Notification No.: 20130308

Description: TBV Transport Cover and CPU

Hardware: TBV-100 and TBV-101 (all models)

Figure 1

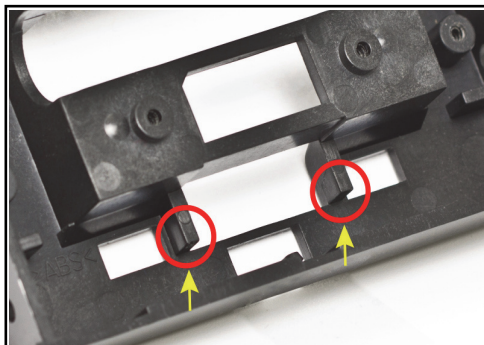
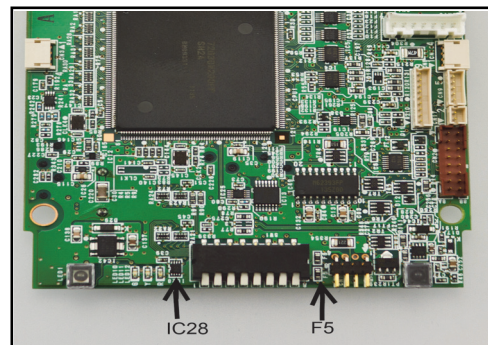
JCM Engineering has received field reports of physically damaged components under the TBV Transport Front Cover. After a detailed investigation, JCM Engineering identified during the installation of the Transport Front Cover, that the protruding ribs on the cover (Figure 1) may damage CPU Board Components IC28 and F5 (Figure 2). The damage can prevent the unit from properly calibrating or can cause unit failure.

JCM Engineering has modified the Transport Front Cover to have a notched rib design to prevent contact with the CPU board components (Figure 3). JCM Engineering is requesting all customers with TBV 100/101 Transports manufactured prior to January 2013 contact JCM to receive replacement Transport Front Covers. This modification became standard on all production units beginning in January 2013.
